CONE PENETROMETER TEST RESULTS

NORTH ANNA COL

**DATA REPORT REV. 0
JANUARY 23, 2007**

SUMMARY OF REVISIONS REV. 2 CPT REPORT (table 1 only revised and issued)

Site: NORTH ANNA COL.
Location: CPT-907 |

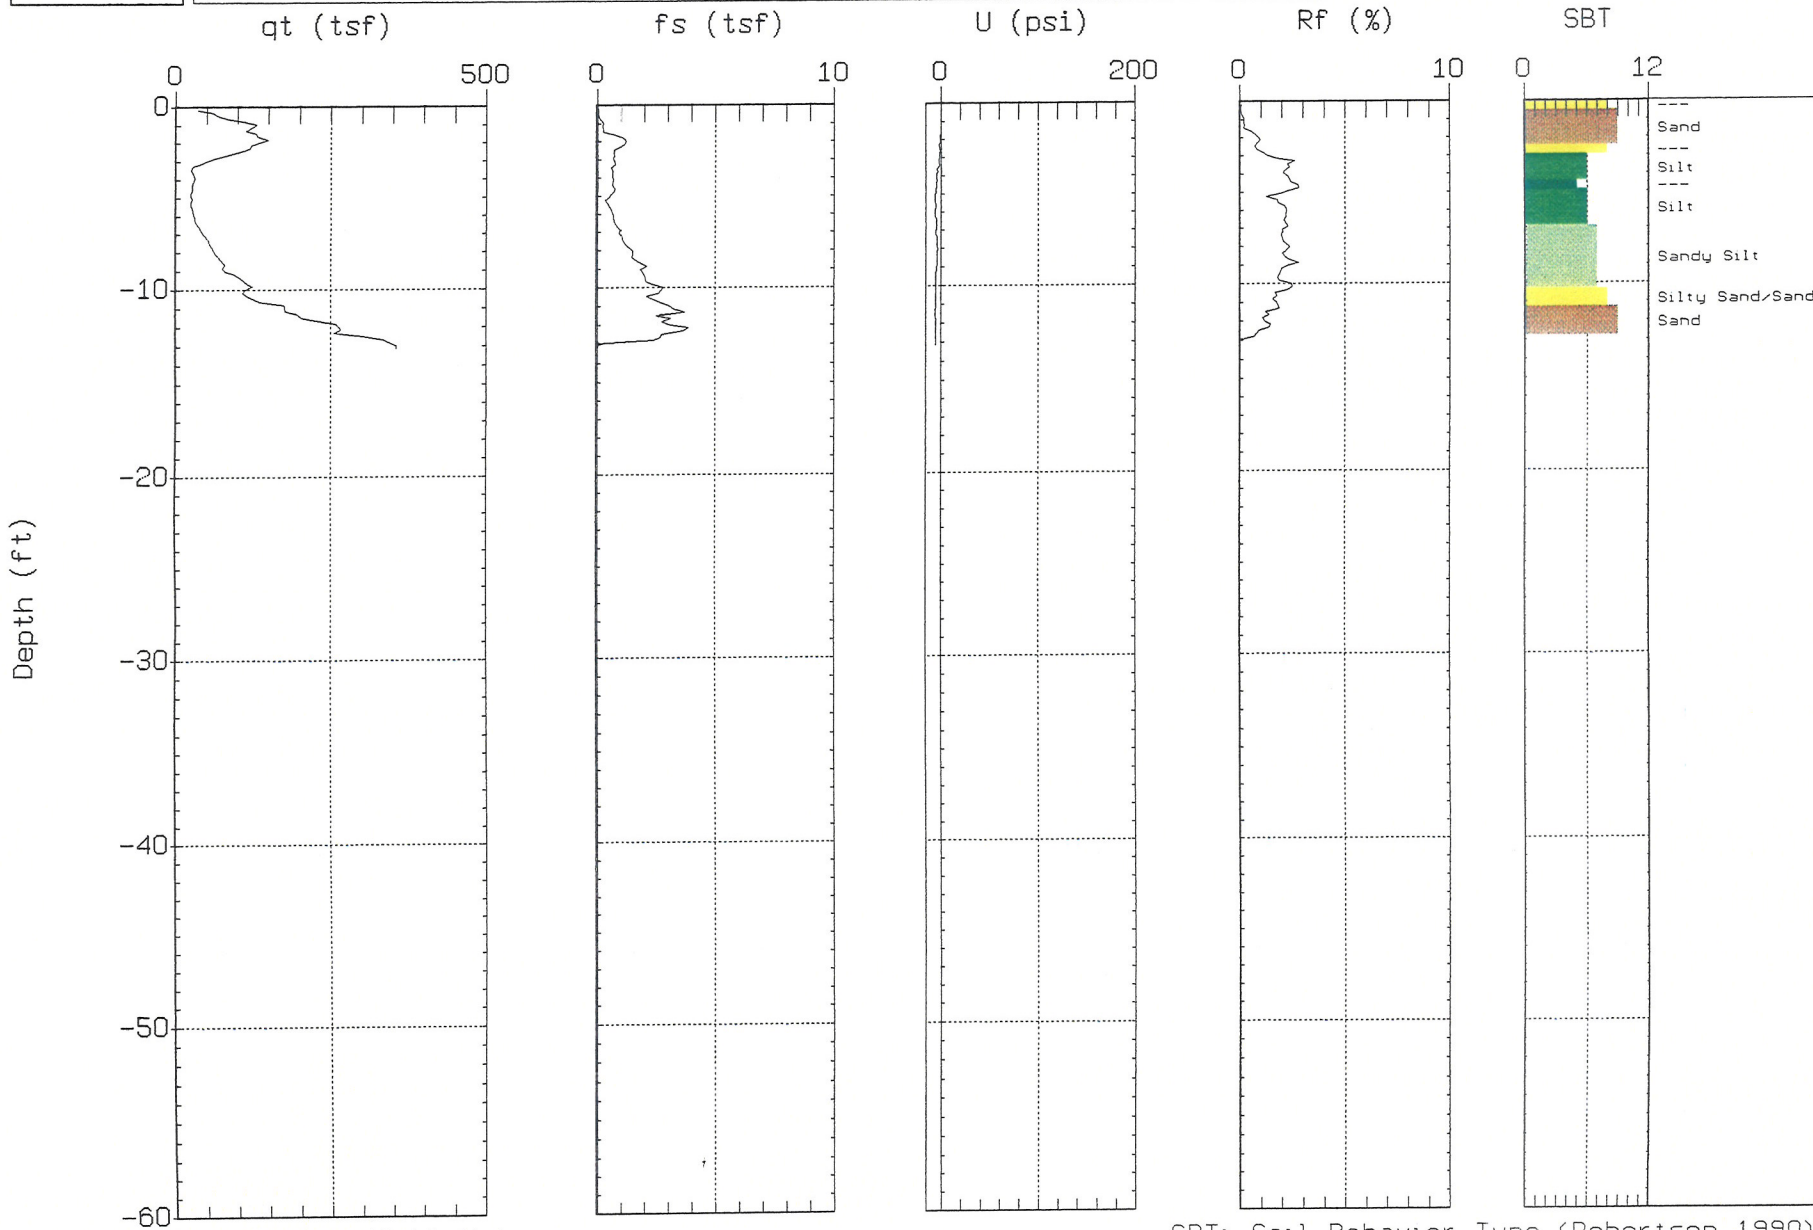
1. Cone Penetration Test Sounding Summary – Table 1. Replaced table to correct mis-numbering of CPT-907 and CPT-917.
2. Plots for correct CPT-907 inserted. No plots for CPT-907 were included in the original report.
3. Replaced plots for CPT-917 with correct plots.
4. Removed plot of Pore Pressure Dissipation Test labeled CPT-907 and replaced with plot correctly labeled CPT-917.
